City of Manzanita

Planning Commission

AGENDA

A. Manzanita Pines

AVERAGE FINISHED GRADES

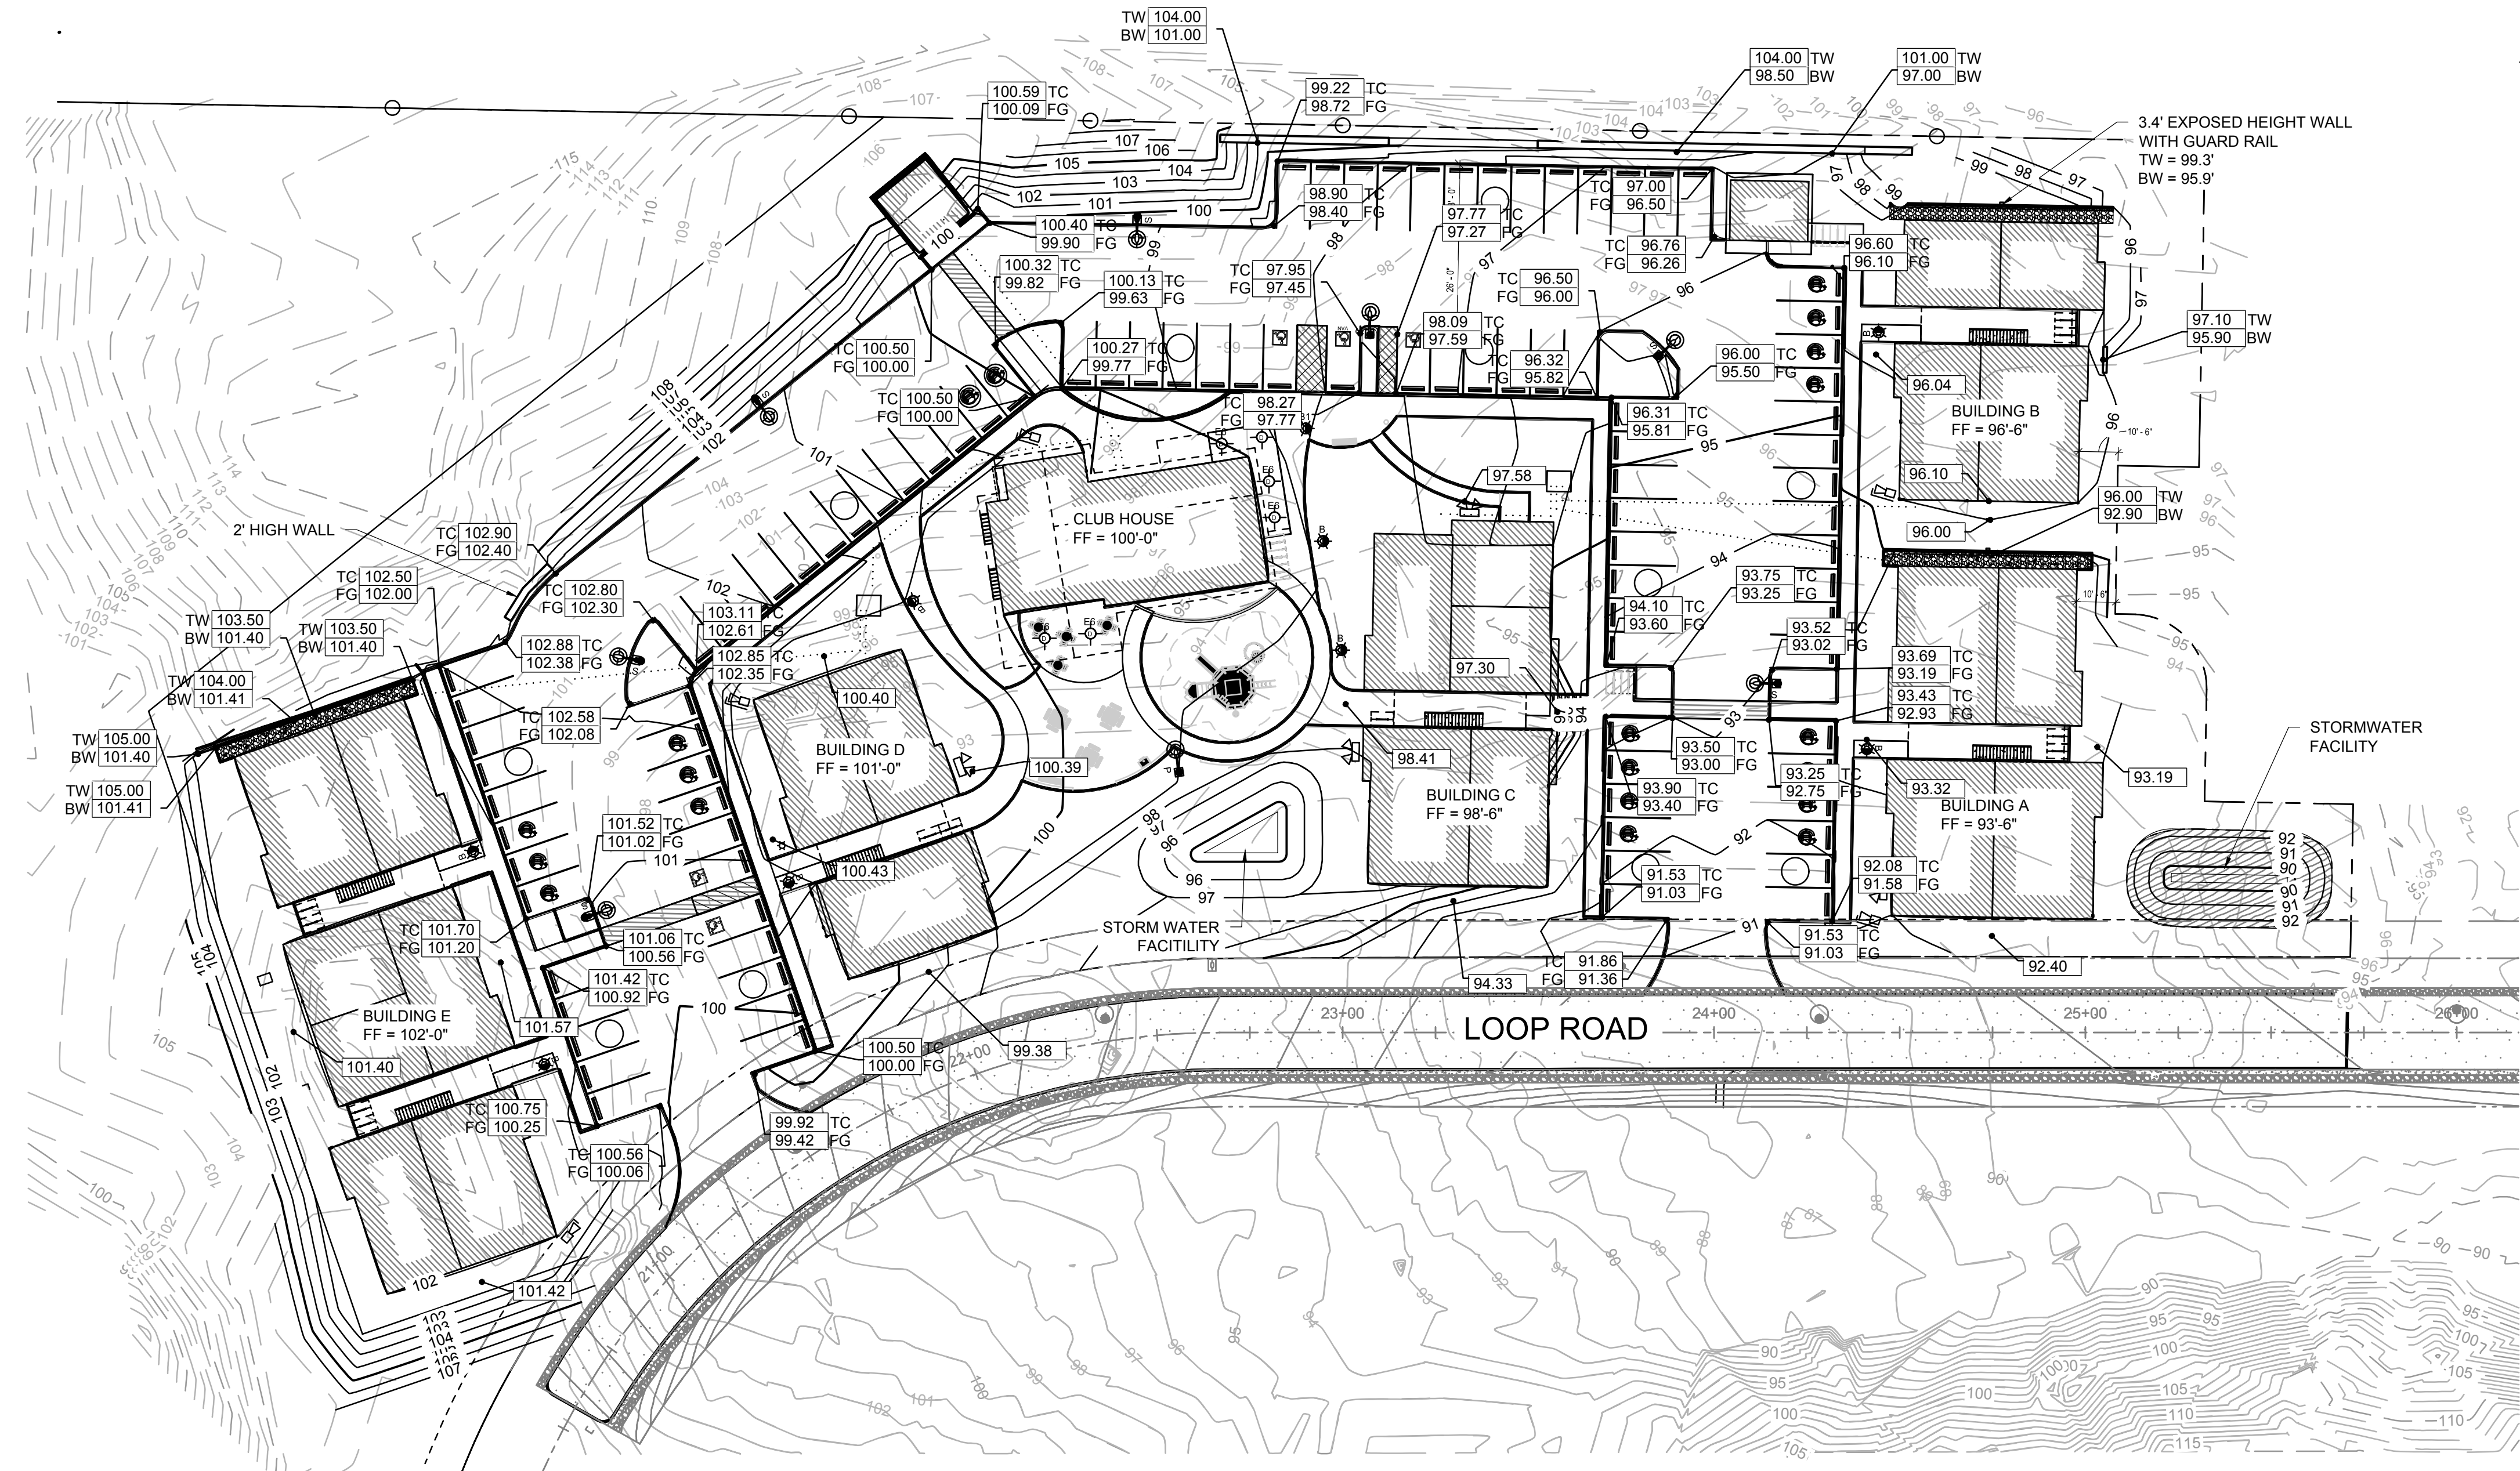
Please refer to the drawing package for additional building height information. Average finished grades around all of the buildings have been provided by the civil engineer on drawing sheet, C1.20. Building height calculations per those average finished grades have been provided by the architect on the Overall Site Plan, drawing sheet, .A01, and elevation views, with building heights noted, have been provided for all of the buildings on drawing sheets, .A20-.A26.

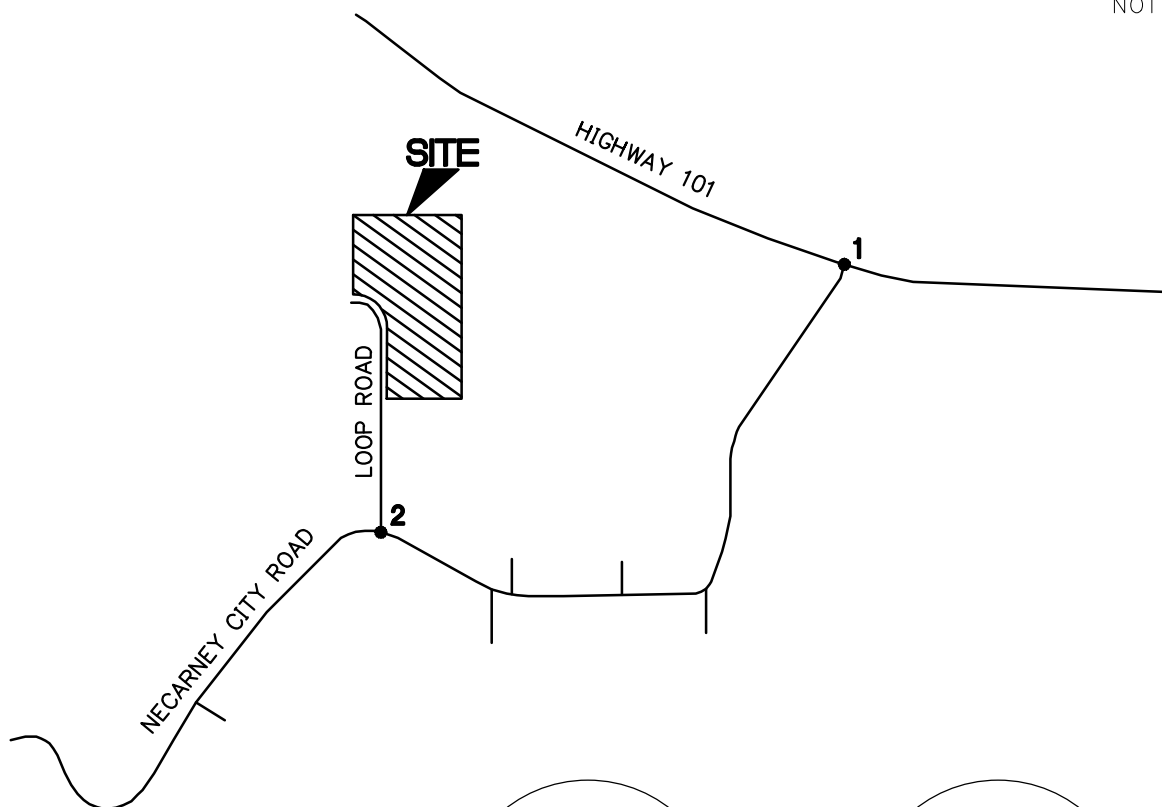
- Figure 9, which pertains to the proposed development's trip assignment, depicts 16 Saturday peak hour trips enter the project site rather than the 15 peak hour trips reported in Table 2 – Trip Generation. This typo carried through the remainder of the Figures and capacity analysis. No revisions are deemed necessary given the increased entering trips provides a more conservative evaluation of development impacts to the transportation system.
